REF: **ENG 14-03**

MODELS: FR/FS/FX 481V, 541V, 600V, 651V, 691V, 730V, 751V, 801V, 850V, 921V, 1000V (FXT00V), FH series

TITLE: CHANGE OIL VISCOSITY FOR AIR COOLED V TWIN 4 CYCLE ENGINE

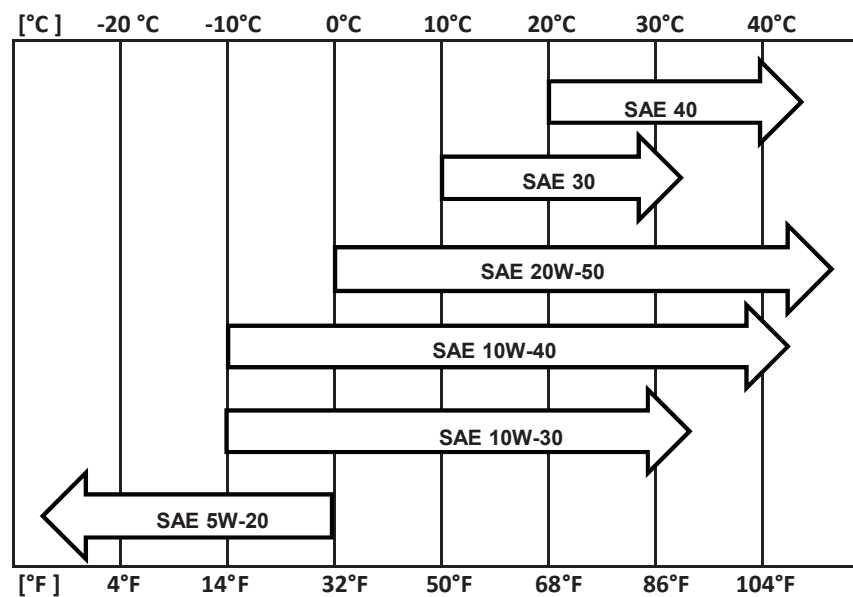
Kawasaki has added 20W-50 grade oil to the viscosity table below. The viscosity table information in the manuals has also changed to match the table below.

o Although 10W-40 engine oil is the recommended oil for most conditions, the oil viscosity may need to be changed to accommodate seasonal temperature changes. Using 20W-50 oil in higher ambient temperatures may reduce oil consumption.

Changes to the oil viscosity table will be included in the updated service and owners manuals for the FR/FS/FX and the FH-D series engines however no change will be made to the manuals for the FH-V series engines.
